**United Walnut Taxpayers (UWT)**  
**P.O. Box 1665**  
**Walnut, CA. 91788**  
**Contact Person, Layla Abou-Taleb, President**

**UWT Response to the July 2017 NOC of Tiered Draft EIR for the Mt. SAC West Parcel Solar Project**

**Response to EIR Section 3.5 Geology and Soils, West Parcel Area, Mt. San Antonio  
College, August 2017** PDF Page 49

## Motorists Traveling Grand Avenue Observe Mass Hillside Losses Inconsistent with General Plan

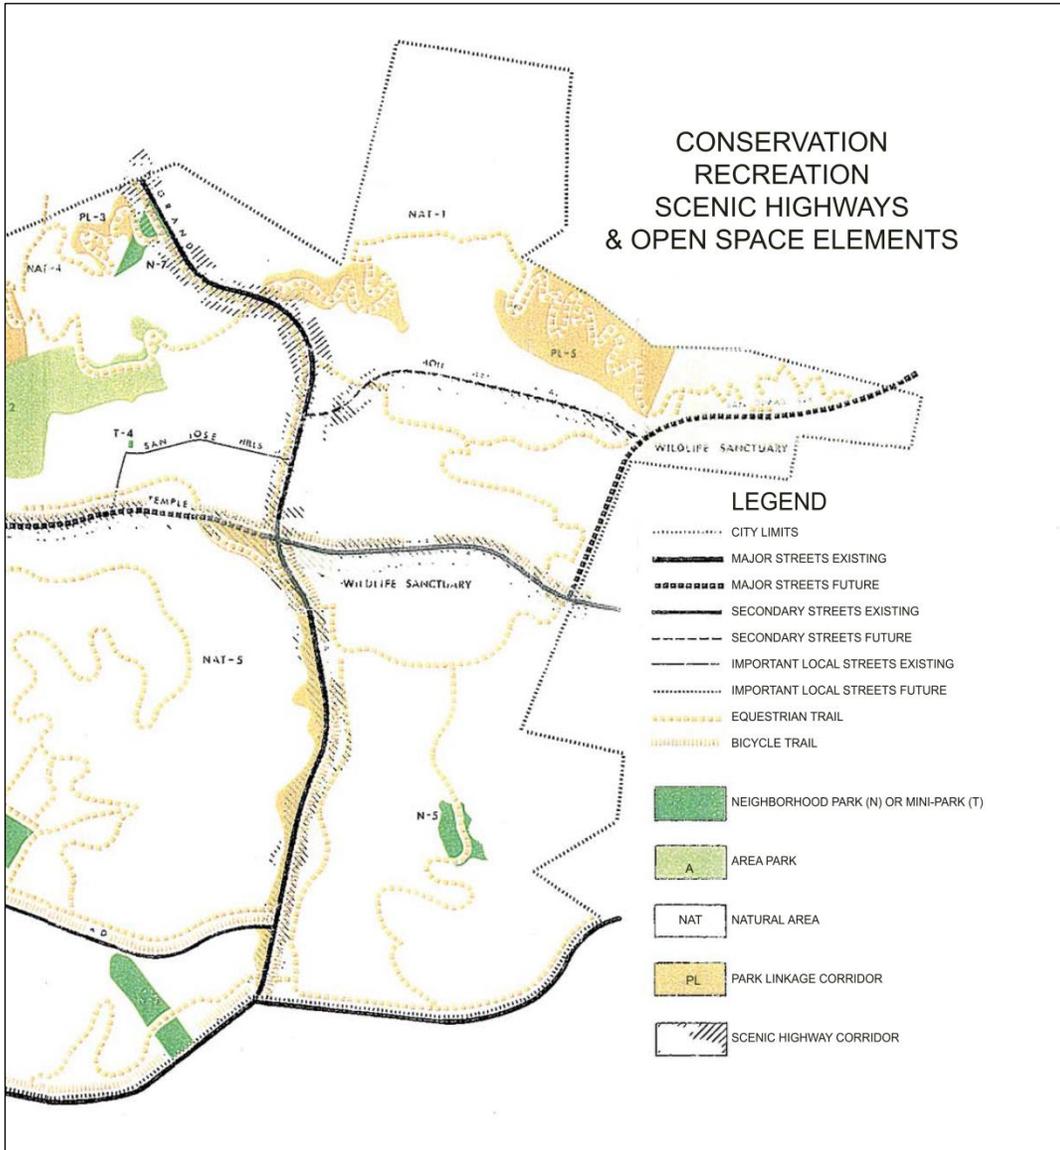
5. Motorists traveling Grand Avenue would observe loss of hillsides, which is inconsistent with the General Plan Scenic Corridor designation of the roadway. The following views of Grand Avenue (photos 1 through 3, below) traveling from south to north from Snow Creek Drive to Amar Road displays the scenic values of Grand Avenue at street level and the significant destruction of native hillsides and vegetation caused by the west parcel project.

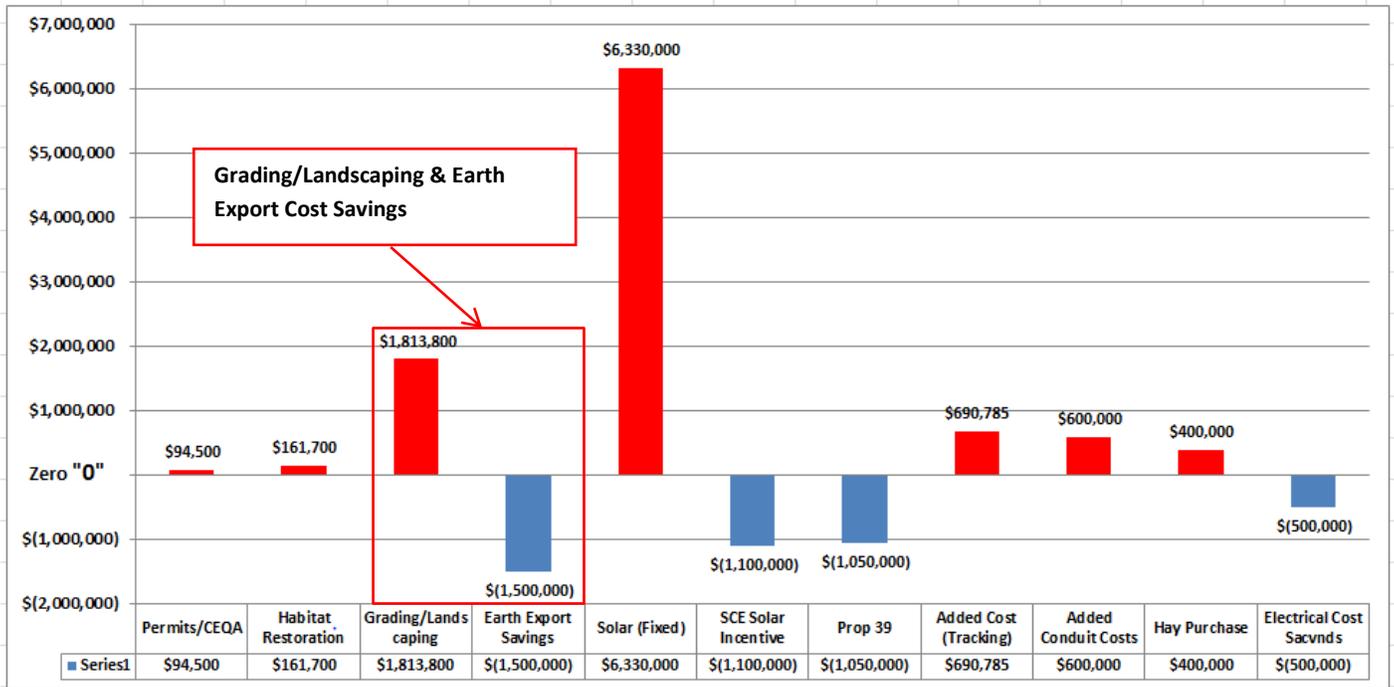
30. Given realistic unit prices in the range of \$14 per cubic yard, and earthwork quantities described above, the total grading cost was determined to be \$6,685,000 (see below), making the west parcel significantly more costly than solar panels mounted atop parking canopies or parking structures.

### Total Project Cost – West Parcel (DEIR) Combined Grading/Landscaping & Earth Export Savings

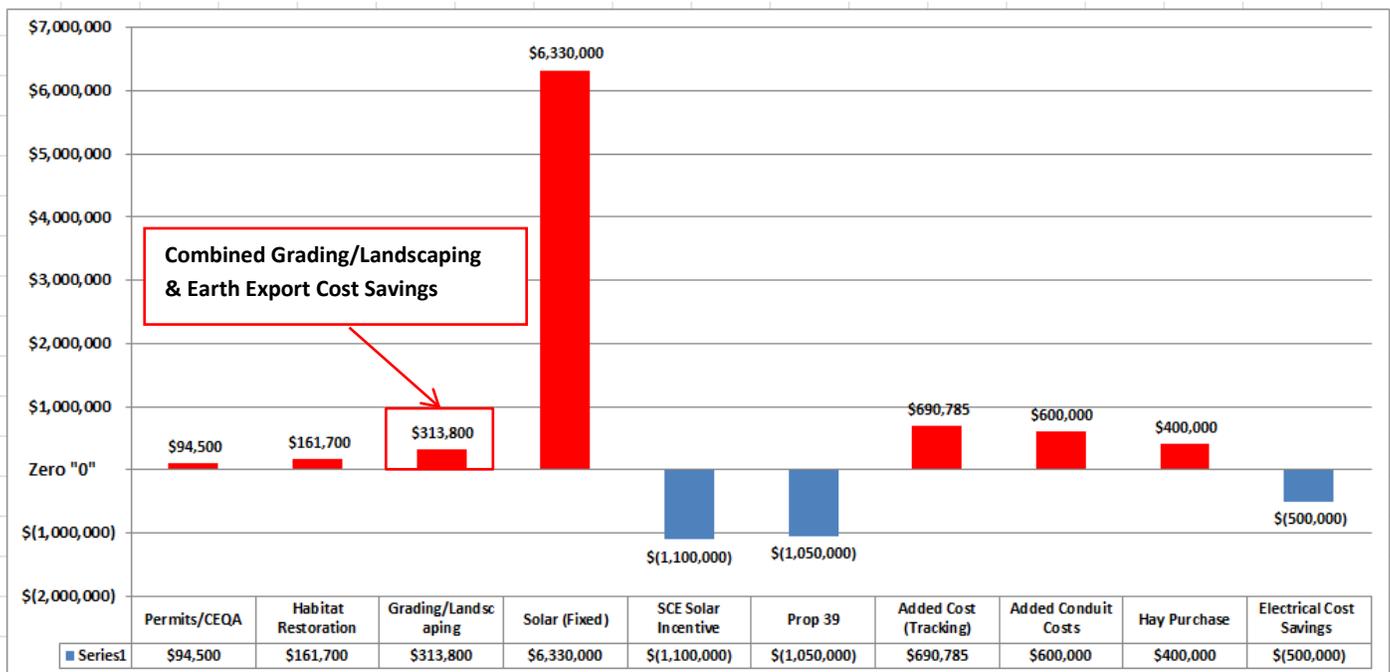
31. The first chart shows the raw WPSP costs in the DEIR. It includes the various costs adjustments and credits applied by Mt. SAC after the construction costs are developed. The third vertical bar is the grading cost. The fourth bar is grading savings (a negative cost) if the stadium hill dirt is exported to the west parcel and not off-site.

32. The second chart shows what happens when the grading cost and the export savings are combined into a net grading cost. The cost of grading virtually disappears because of combining a positive and a negative cost. As indicated above, it may not be necessary to export dirt off site, which eliminates the export cost savings and results in a further increase to west parcel costs.

# Figure 1

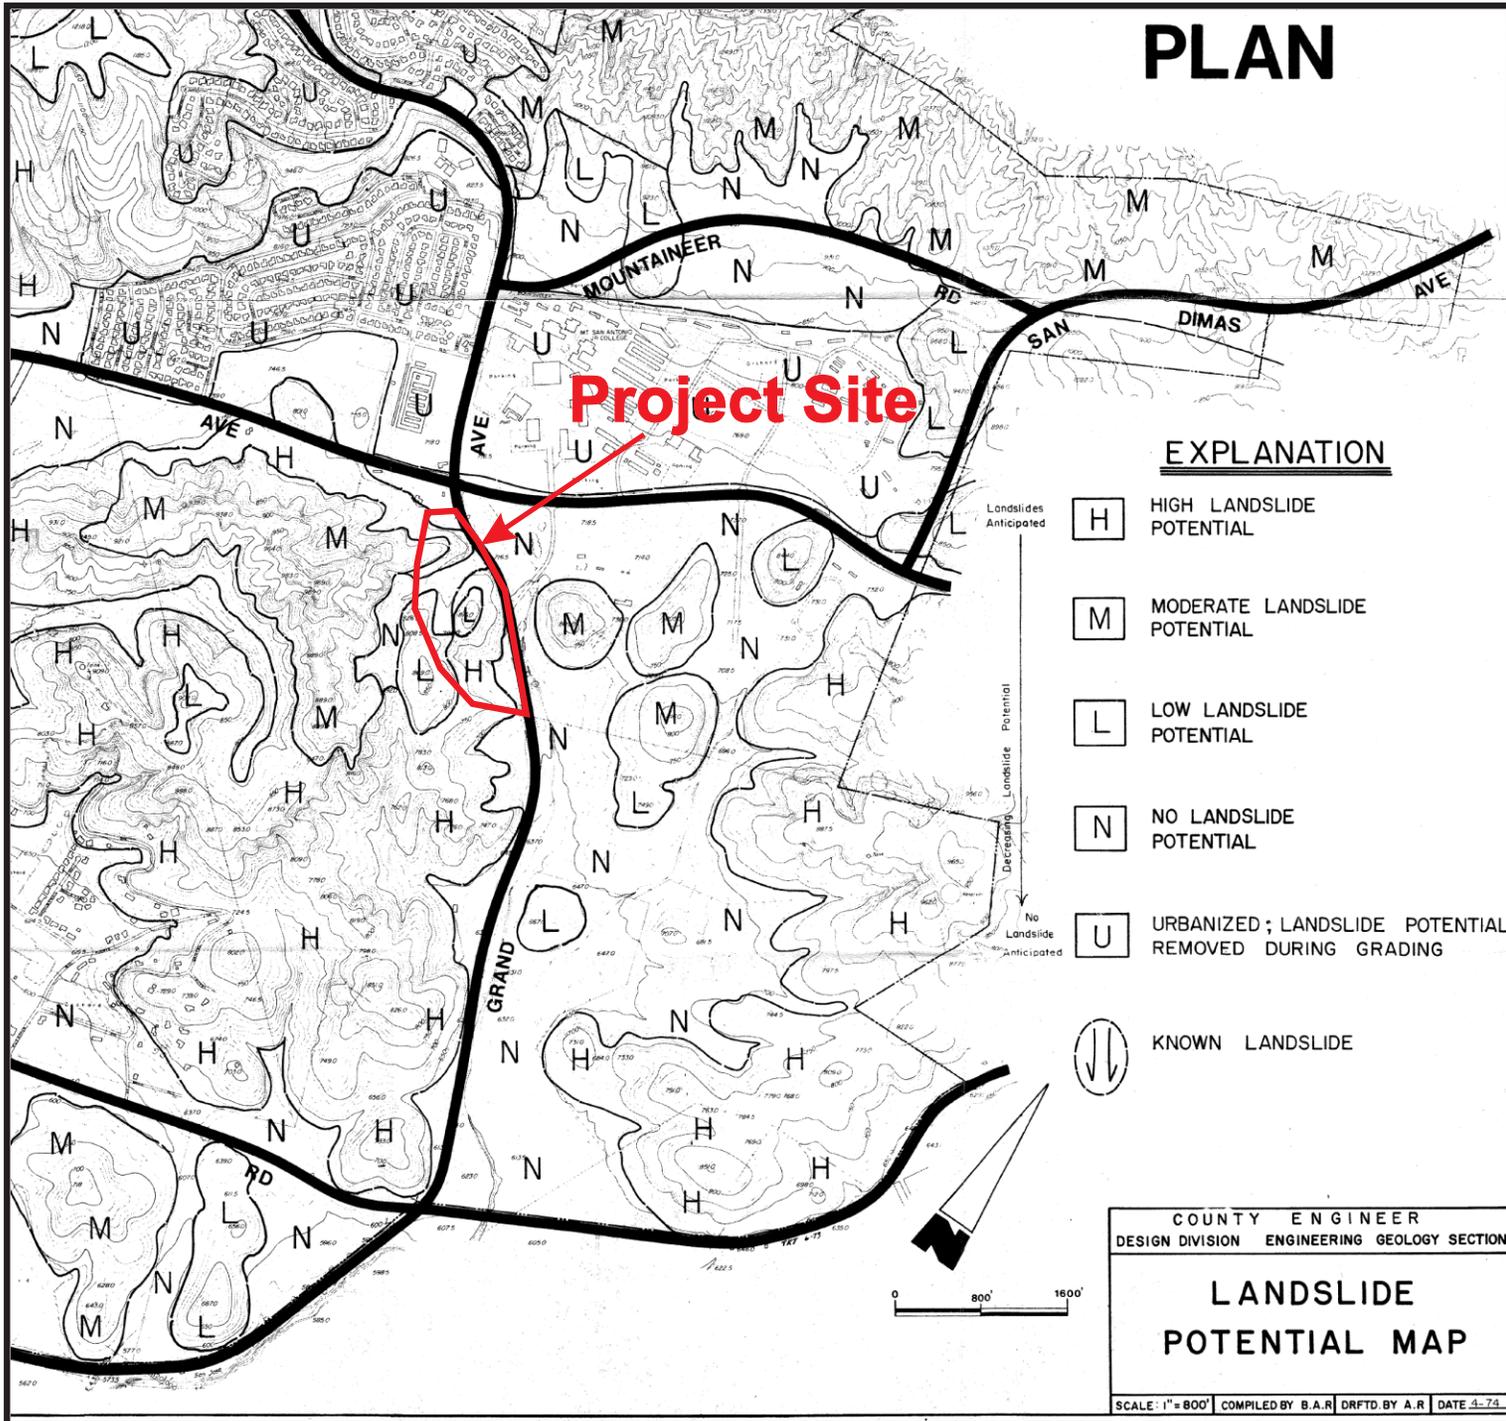
The Dibblee map (1989) was presented by Converse in their report and indicates the site is underlain by bedrock of the Tertiary Sycamore Canyon Formation which is the uppermost member of the Puente Formation, and that bedding is generally striking northwest-southeast and dipping 15 to 30 degrees to the northeast. The surrounding areas are indicated as being underlain by the Tertiary Yorba member of the Monterey (Puente Formation) with similar bedding orientations. According to the Geologic Map (City of Walnut, 1974), the site is underlain by bedrock of the Puente Formation. This map (Figure 1) indicates that the central knob and adjacent hilltops are underlain by sandstone

**Figure 2a**  
*Terrestrial Solutions Inc.*

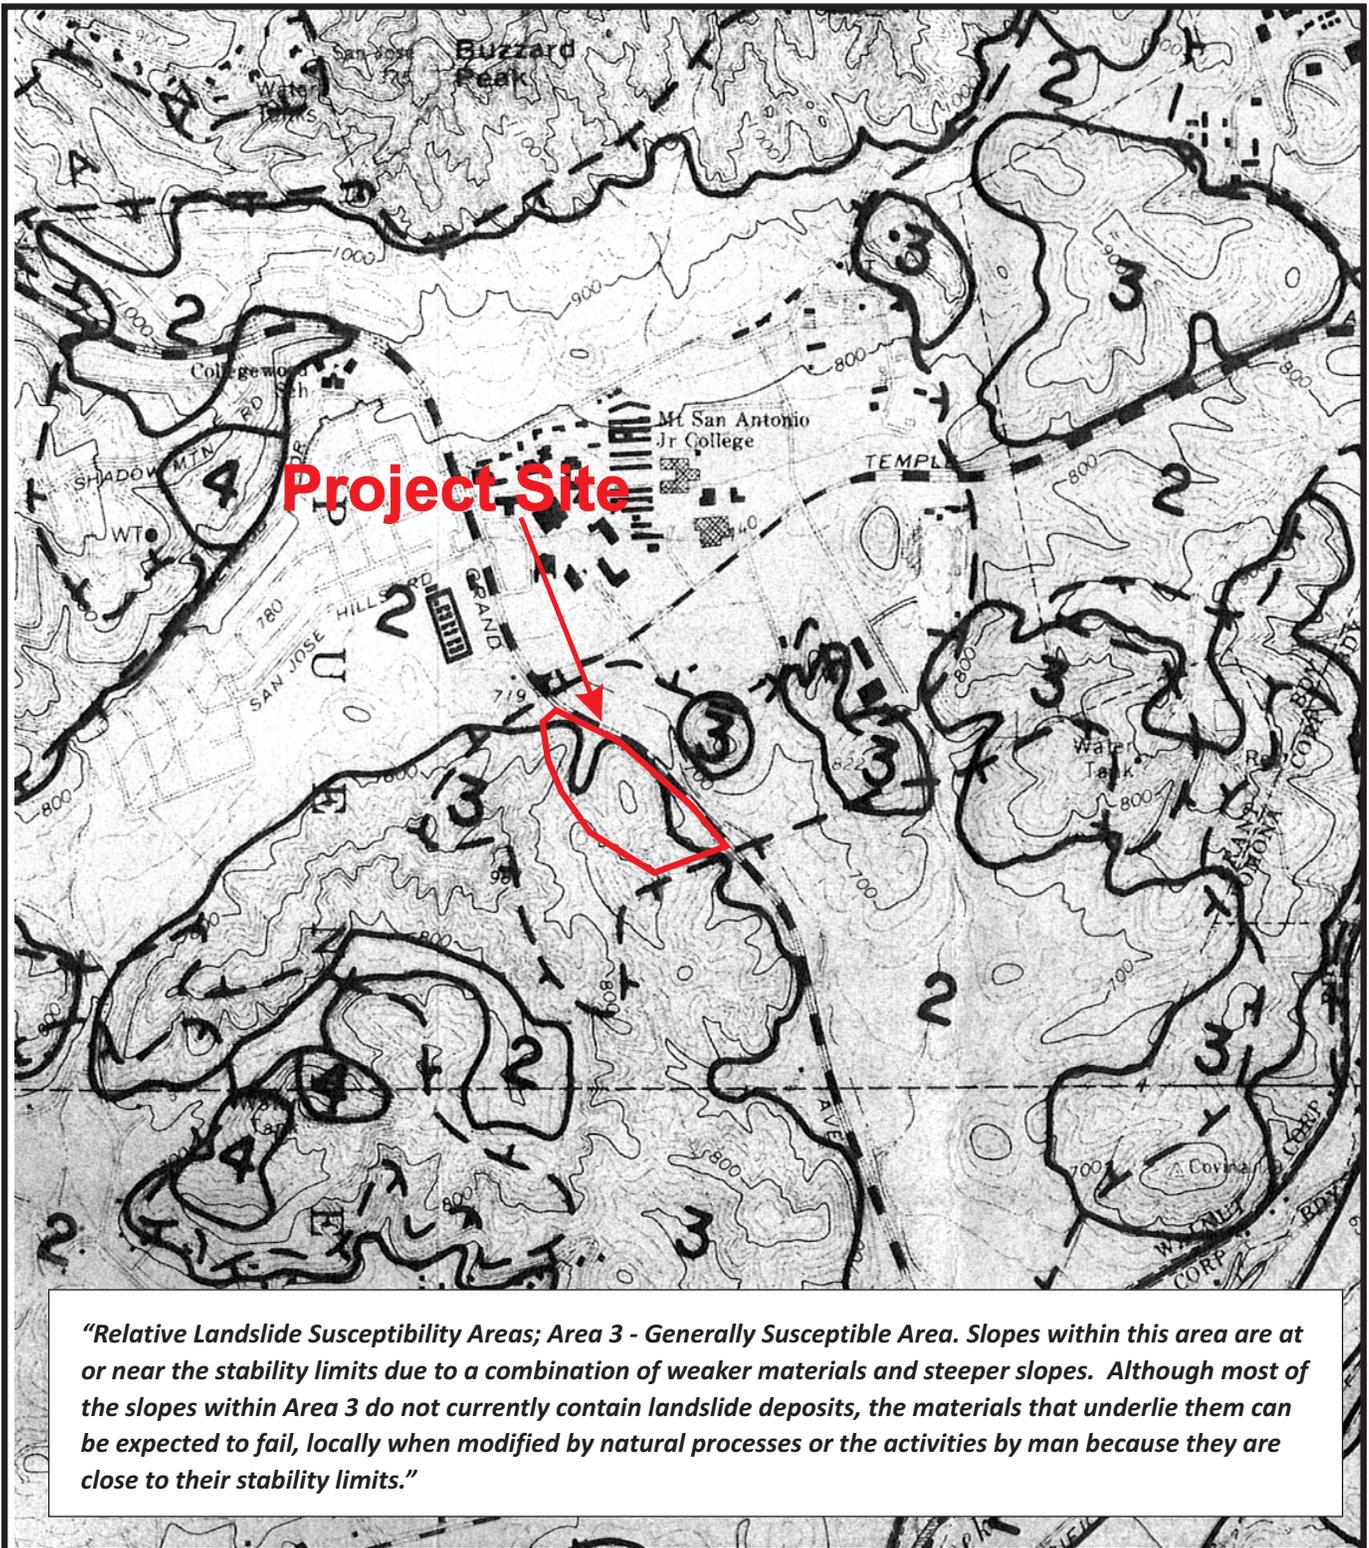
These figures clearly indicate that the proposed project is within areas that were previously determined by governing agencies to have a significant potential for slope instability and landsliding.

**Figure 5**

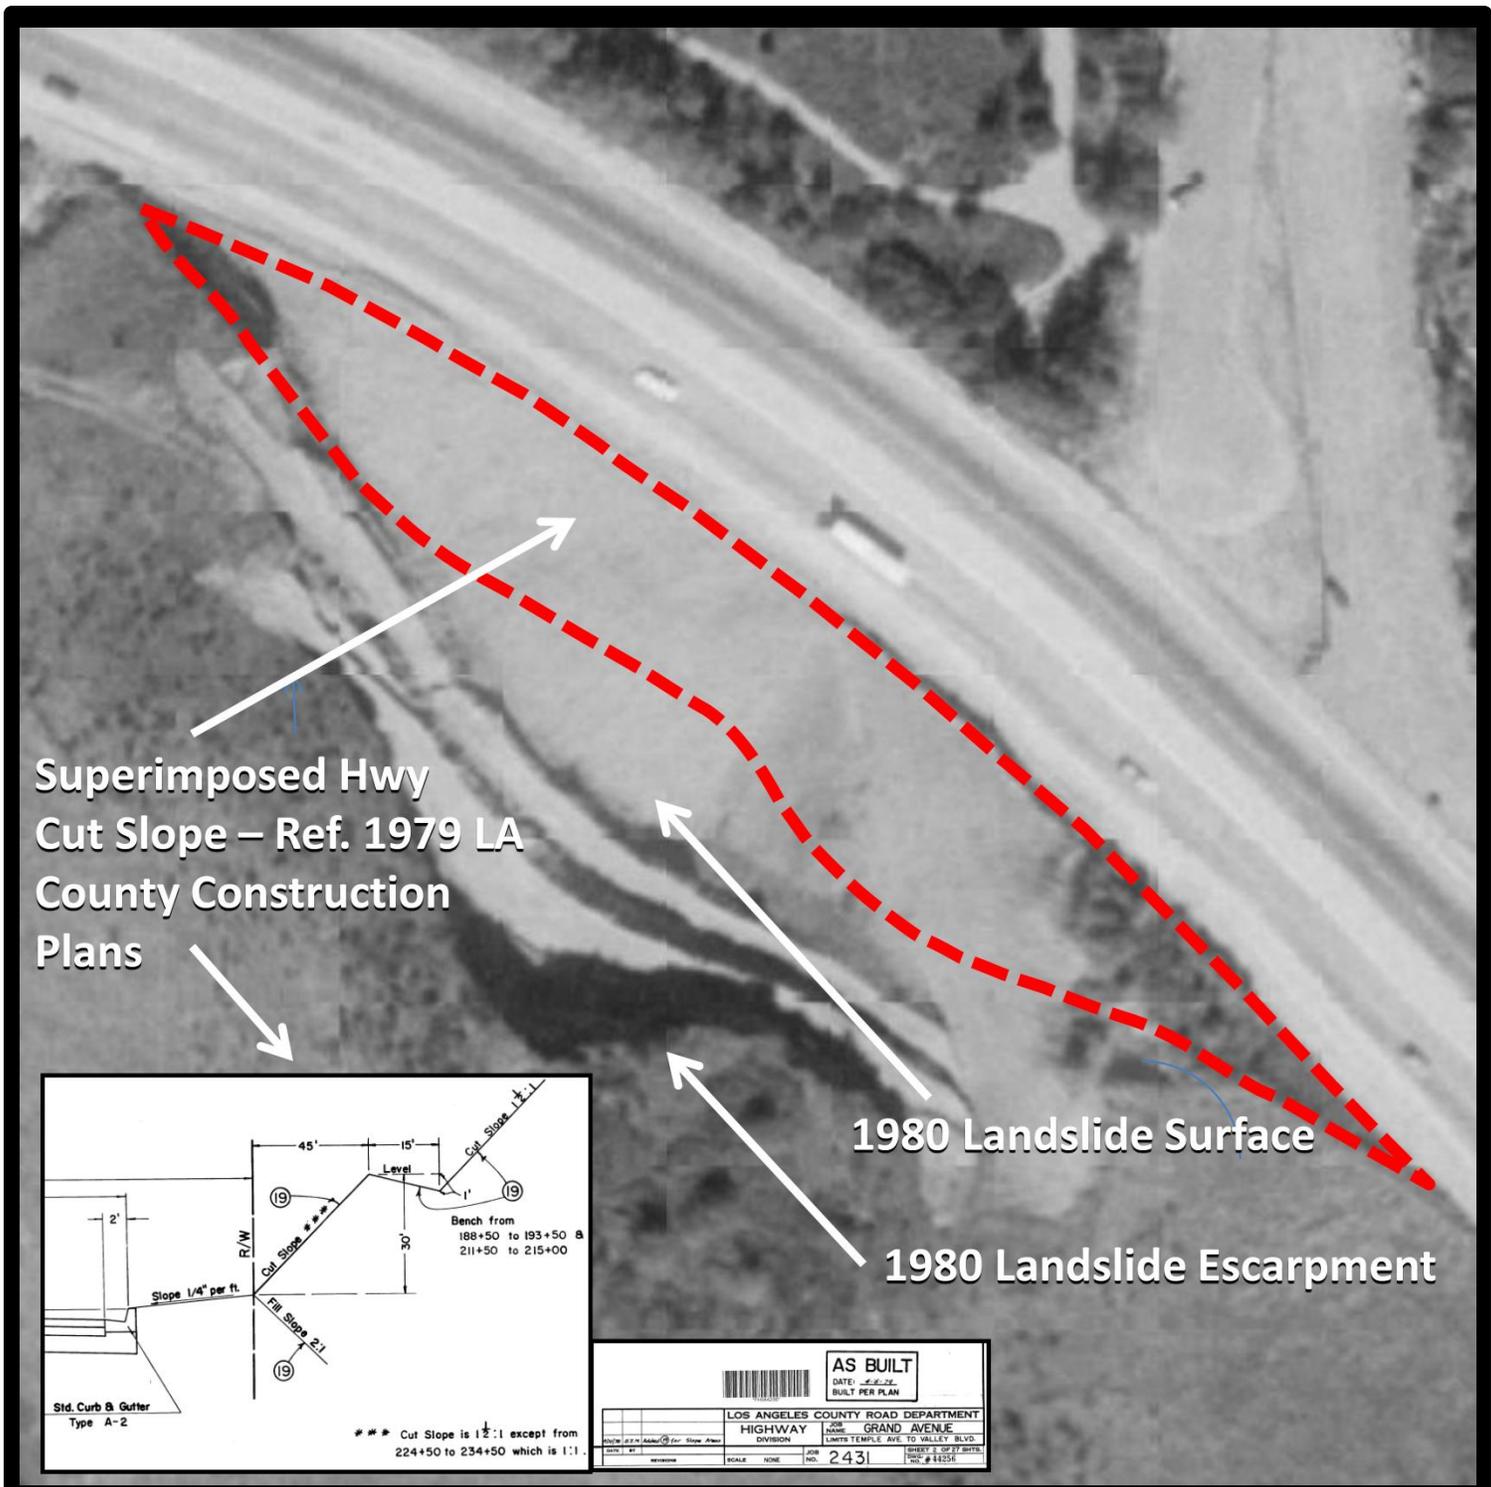
The slope along Grand Avenue consists of variable cut, fill, and in some locations, fill over the existing slope. As discussed earlier, the central hill portion of the site along Grand Avenue is underlain by a landslide. The proposed cut slope in this area will most likely not remove all the landslide debris, and the underlying cause(s) of the landslide. The geologic conditions (including the presence of the landslide) have not been modeled by Converse for the differing conditions along the length of this proposed slope. No specific stability analysis was provided for any of this variable slope which is nearly 2000 feet in length and up to 80 feet in height. Grand Avenue is a major roadway within the City of Walnut and is located at the toe of this proposed slope. Therefore, understanding the stability of this slope is a critical aspect of this project.
